ADDENDUM No. 2
REQUEST FOR TENDER No. Doc5098158970
CONTRACT No. 25-PR-037

FOR: Bluffer's Park East Washroom Improvements and Exterior Works

- R1.** Replace Drawings E101, E201, E301, E401, E501 & E601 with the attached revised drawings issued with this Addendum.

E101

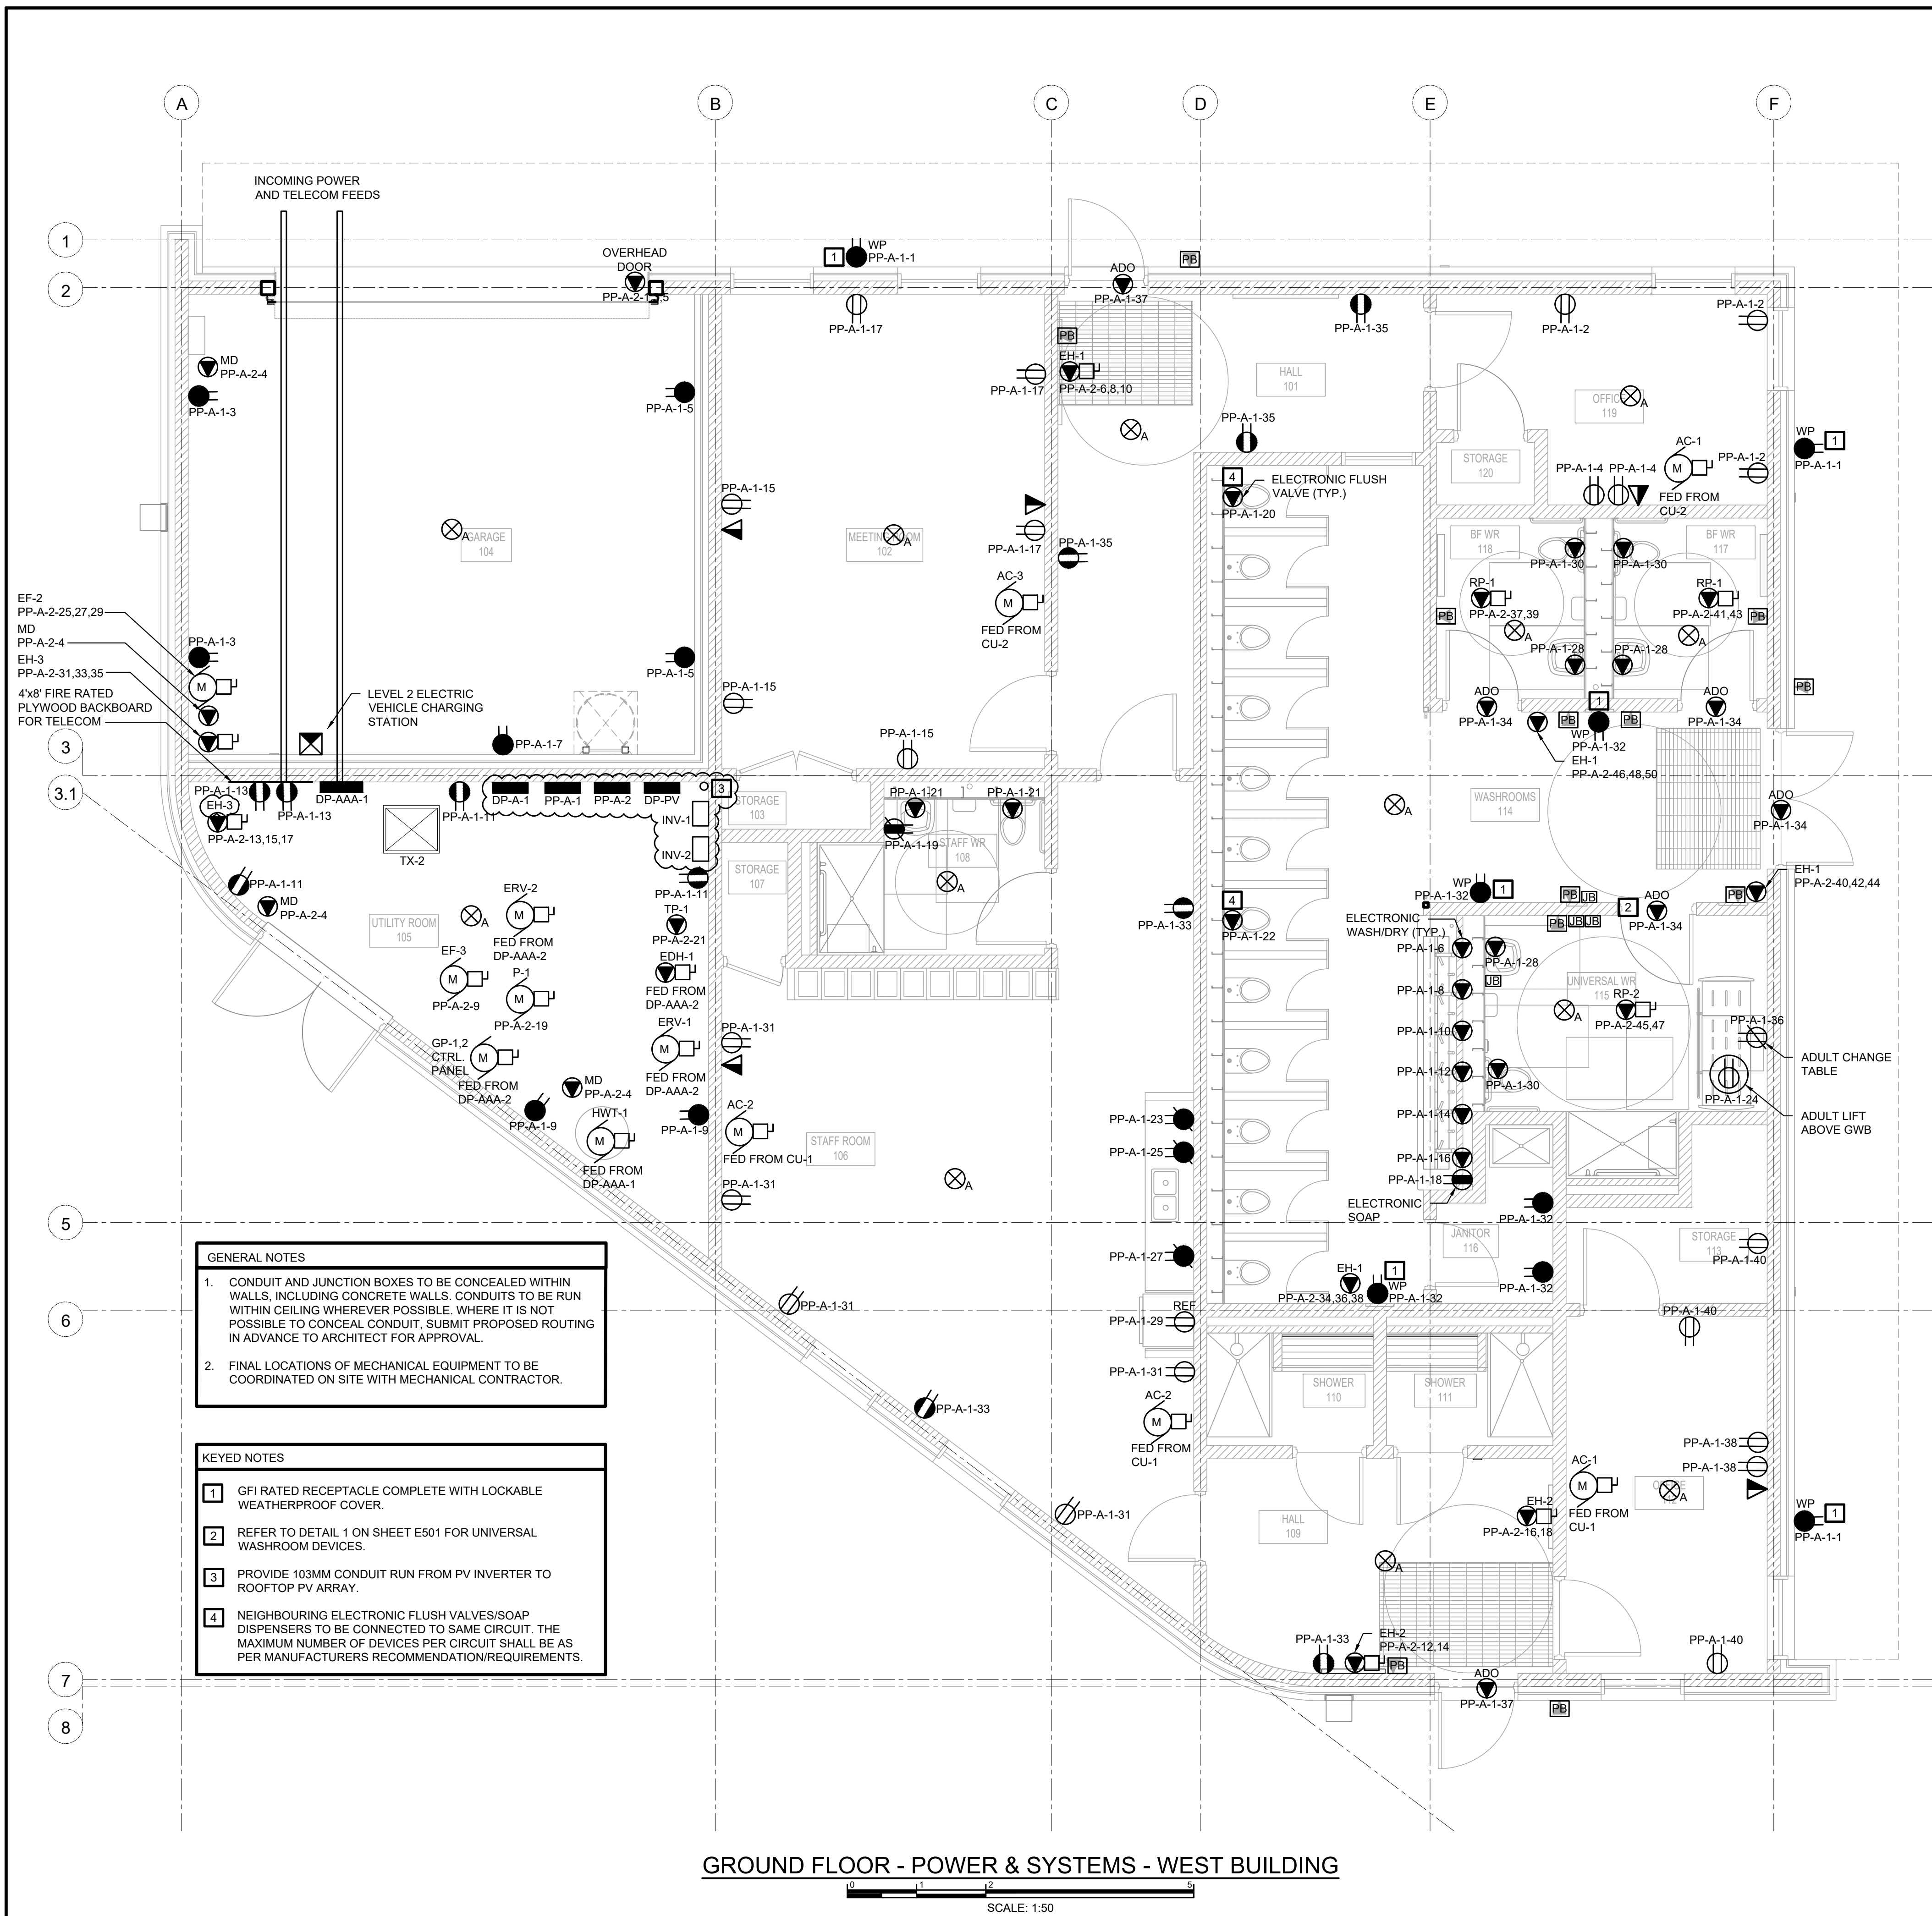
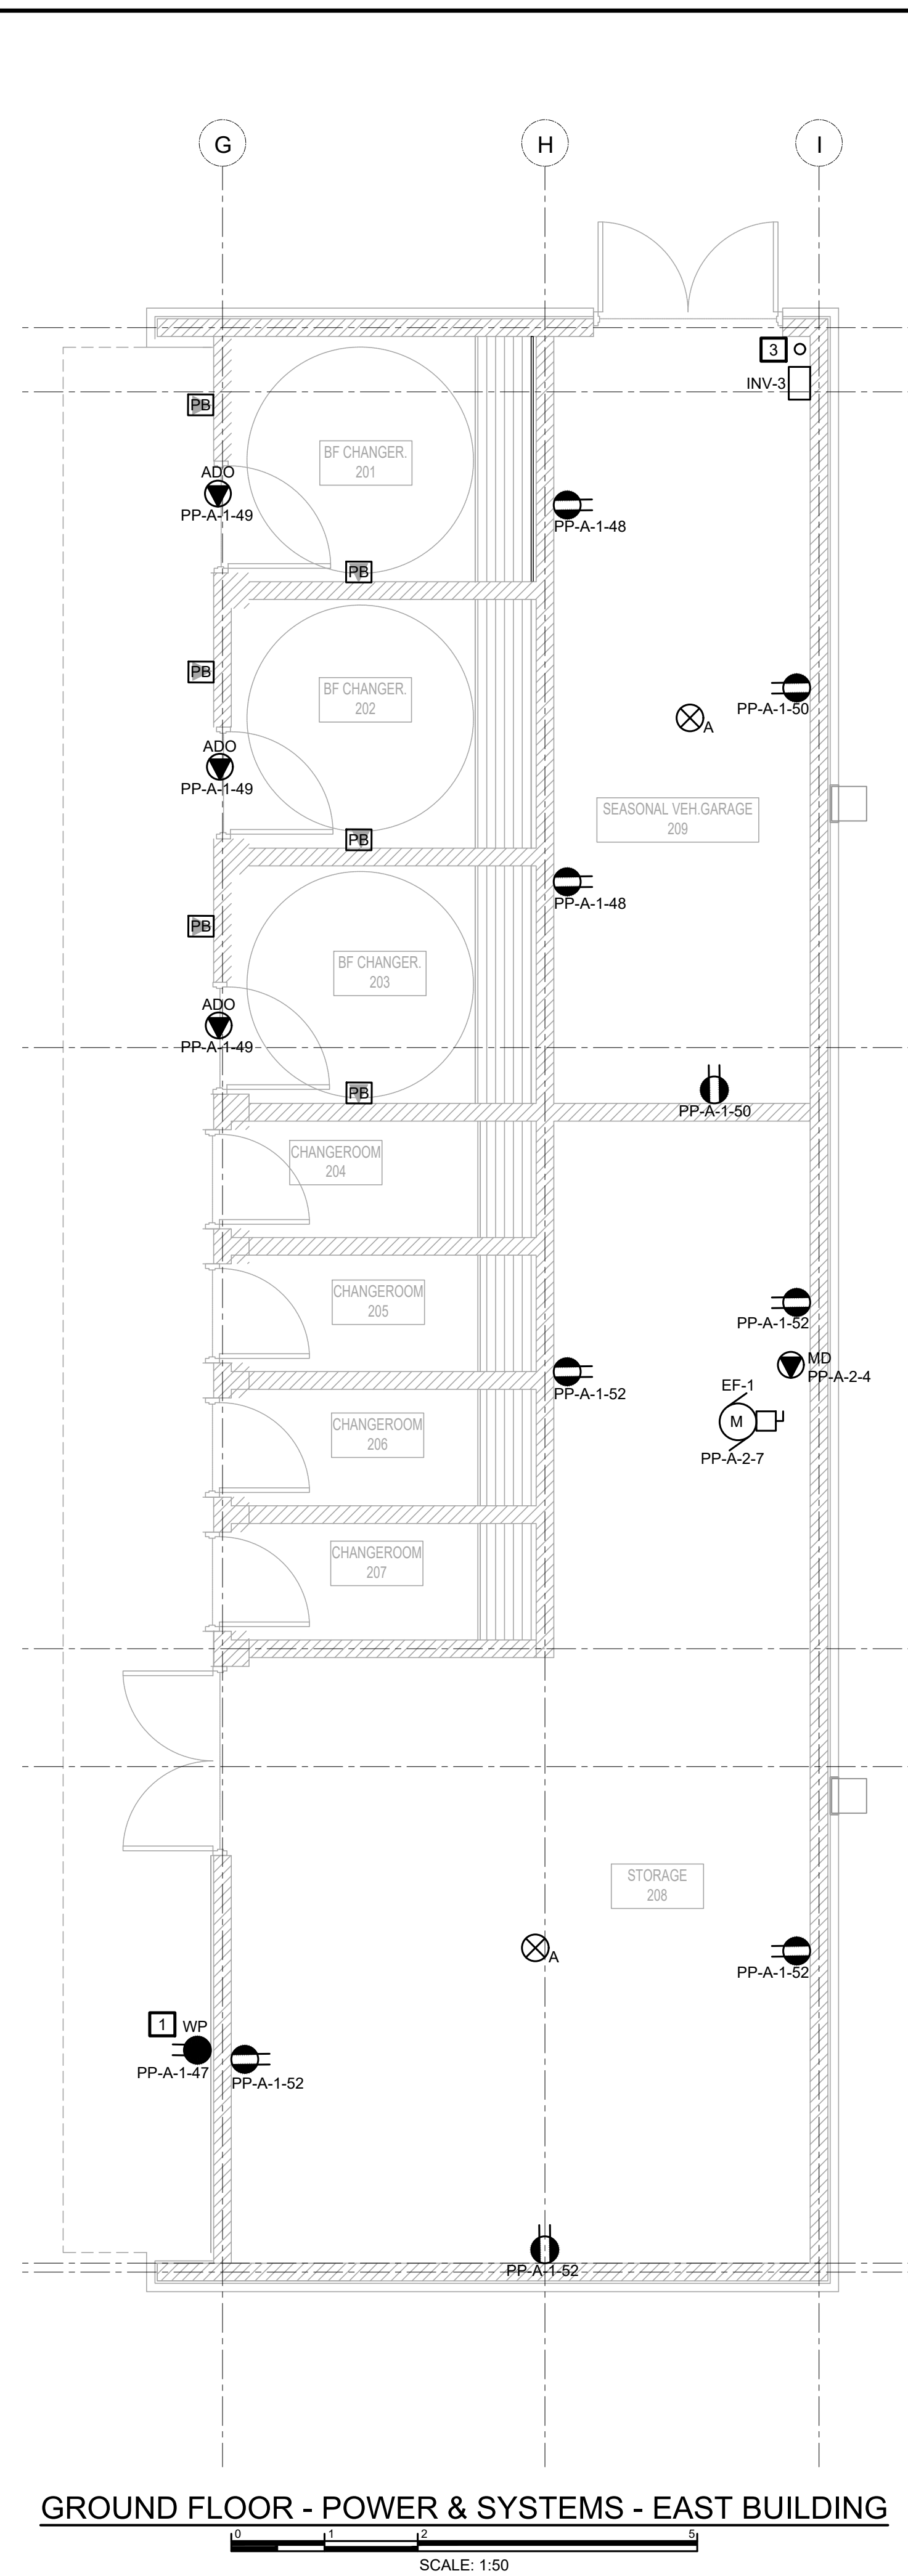
1.1 E101 – GROUND FLOOR – POWER & SYSTEM PLAN

- a. Equipment label updated from EH-4 to EH-3.
- b. Panel DP-A-1 added to Utility Room 105, as shown.
- c. Inverters INV-1 and INV-2 relocated, as shown.

Q8. *Referencing DWG E101 and Mechanical Equipment Schedule, EH-4 is not listed. Drawing says being fed from Panel PP-A-2 13,15,17, nothing on panel schedule. Please confirm.*

Q10. Please identify where DP-A-1 is located on drawing E101.

A8. EH-4 was mis-labelled, and has been updated to EH-3. Circuit to remain the same. EH-3 has been added to panel schedule PP-A-2 on E401 in this Addendum.

A10. *DP-A-1 has been added to the Utility Room on E101 in this Addendum.*
